United States Patent and Trademark Office

APPLICATION NO.	FILING DATE	FIRST NAMED INVENTOR	ATTORNEY DOCKET NO.	CONFIRMATION NO.	
10/750,698	01/02/2004	William D. Cottrell	8534-001	3826	
75	590 05/23/2006		EXAMINER		
MacCord Mason PLLC 1600 Wachovia Tower			EDELL, JOSEPH F		
300 N. Greene		ART UNIT	PAPER NUMBER		
P.O. Box 2974		3636			
Greensboro, NC 27402			DATE MAILED: 05/23/2006

DETAILED ACTION

Diagram A - Annotated Figure 2 of Edwards et al.

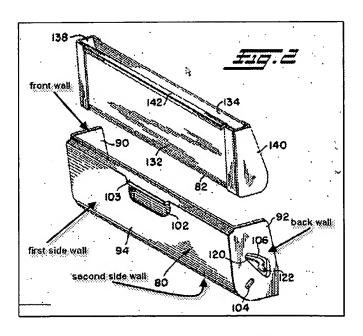
Edwards et al. disclose a vehicle mounted peripheral device station that includes all the limitations recited in claims 1-19, 15, and 16. Edwards et al. show a vehicle mounted peripheral device station having a vehicle seat 12 (Fig. 1) capable of receiving a removable headrest 16 (Fig. 4), a peripheral device 82 (Fig. 2), an adaptor 14 (Fig. 1) having first and second spaced posts and capable of securing the peripheral device to the vehicle seat, a support surface 80 (Fig. 2) attached to the peripheral device and the adaptor, and pins 108,110 (Fig. 4) are capable of securing the peripheral device to the adaptor wherein the support surface is a plate having a plurality of edges attached to a plurality of side walls spaced to frictionally receive the peripheral device, and the plurality of side walls includes a front wall with a reduced height, a first side wall, a second side wall, and a noncontinuous back wall (see Diagram A below).
